Work Order ID 98545

Item Name: Replacement Skidtube

DRAWING NO. D2580	TITLE 205 SKIDTUBE ASSEMBLY	REV. E	DART AEROSPACE LTD ENGINEERING ORDER	D.E.O. NO. D2580-E-1	SHEET NO. SHEET 1 OF 1	SCALE NTS
DRAWN <i>UP</i>	CHECKED <i>ASS</i>	MFG. APPR. <i>EC</i>	APPROVED <i>[Signature]</i>	DE APPR. <i>[Signature]</i>		
DATE 11.12.13	DATE 11.12.13	DATE 11.12.13	DATE 11.12.13	DATE 11.12.13

CHANGE ALL C'BORED WELDED CROSSBOLT SPACERS TO SWAGED SPACERS

SECTION B-B D5-2
SCALE 5X

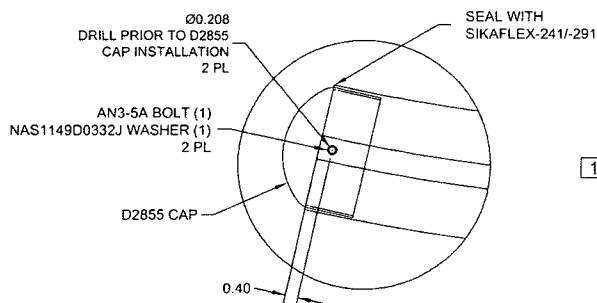
SECTION B-B, SECTION F-F, & SECTION I-I ARE AMENDED AS FOLLOWS
FOR ALL HOLES THAT WERE ORIGINALLY C'BORED:

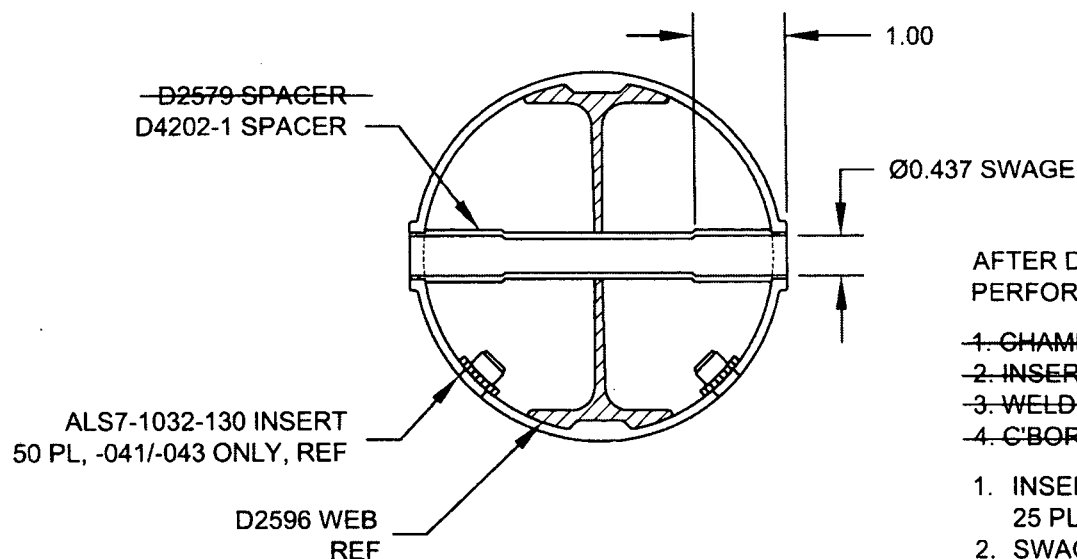
4		* D2579	CROSS BOLT SPACER
20	20	25	D4202-1	SPACER

*** FOR -045 SKIDTUBE ONLY:**

WELD 4X D2579 SPACERS PER DWG
IN LOCATIONS MARKED "NO C'BORE".
REF SHEET 4 OF DWG.
